OFFICE OF THE HISTORIC PRESERVATION COMMISSION

**RE: HISTORIC PRESERVATION COMMISSION APPLICATION NO. HPC 2021-032
BLOCK 226 LOT 13 ALSO KNOWN AS 63 Webb Ave**

Preliminary Review Notes

63 Webb Ave – Window Report

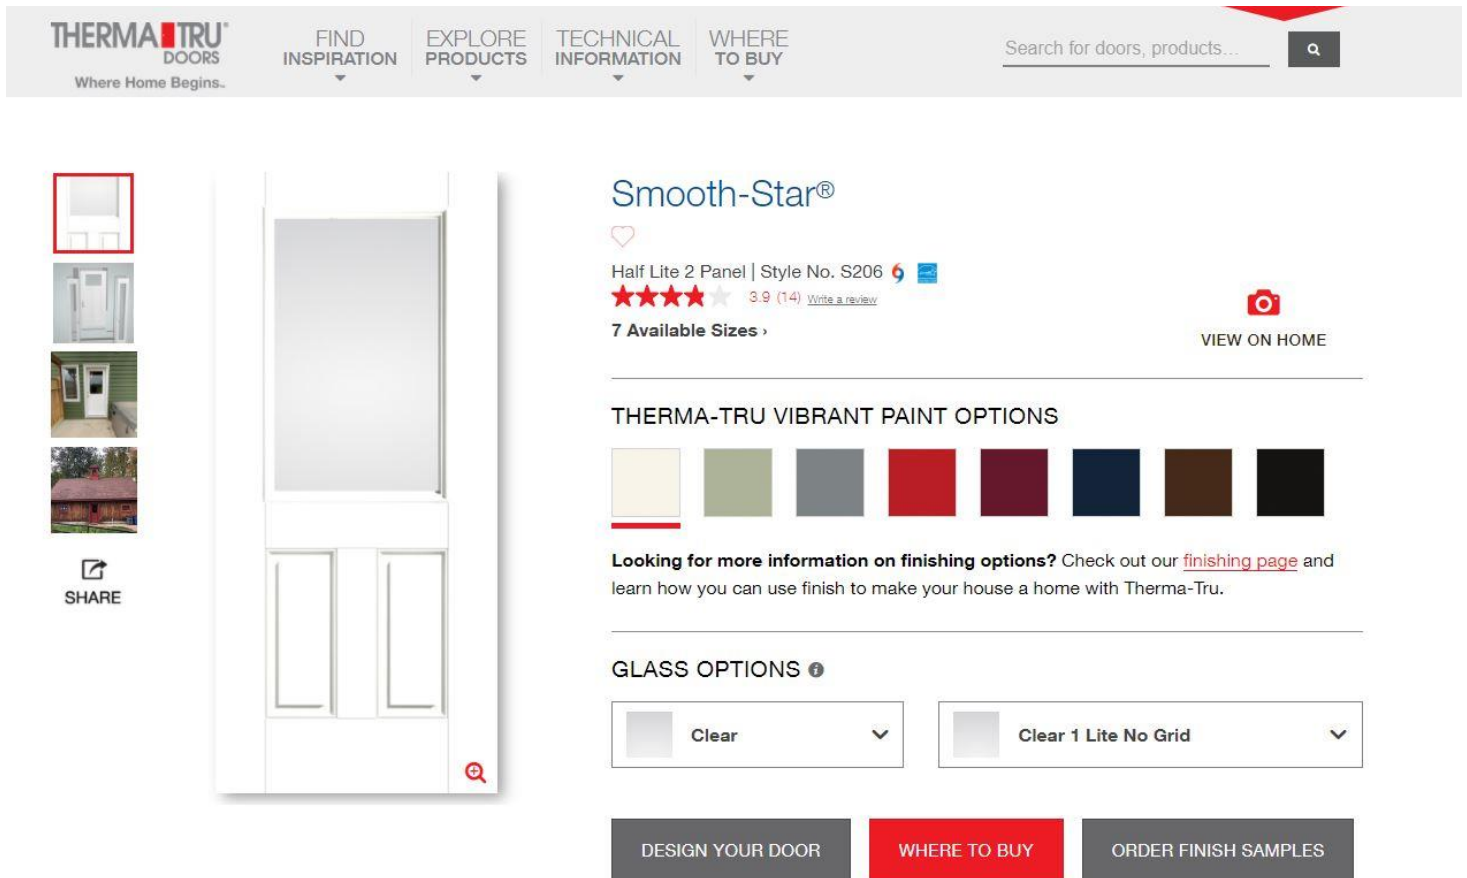
1. Please select your color choice for siding.
2. Please provide a drawing of the AC condenser screening. Fence is not sufficient.
3. Please document the condition of the windows on the front elevation, at the first floor, original one over one wood windows located in the bay area.
4. Please provide a catalog cut for the rear door north elevation.

On Thursday, March 25, 2021, I visited 63 Webb Avenue to evaluate the condition of (4) first floor, south facing windows in a bay configuration in the living room. These windows are not in proper working order. Specifically, the windows do not track correctly and get stuck upon both opening and closing. There has been significant sagging in the bottom sill portion of the window frame which has caused the bottom sashes to not seat properly leaving significant gaps when in the closed position. This condition has caused a previous homeowner to install exterior storm windows to prevent wind and rain to enter. It is further noted that there have been unsuccessful previous repairs made to these windows.

In my opinion, the cost of repairing these windows will far exceed the cost of replacing these windows and the windows will still be inferior to new ones.

SIDE ELEVATION (EAST)
1/4" = 1'-0"

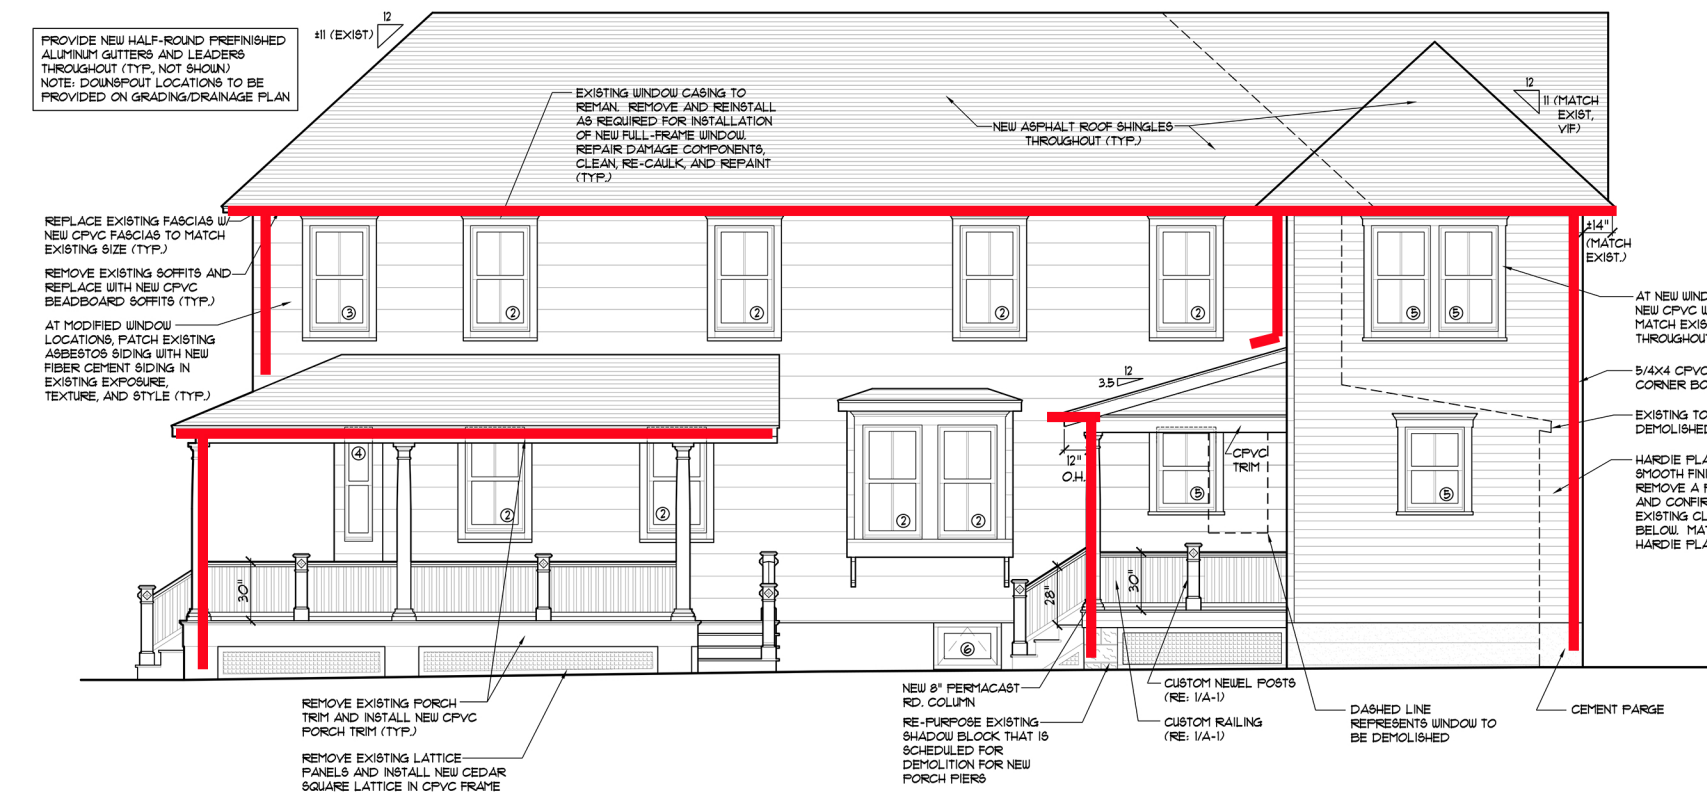
1. On the east elevation, one window located towards the rear of the existing structure is proposed for removal and relocation to align with the existing second floor window above.
2. Lack of windows on the west elevation.
3. Roof form being used over new addition.
4. Gutter and downspout locations.
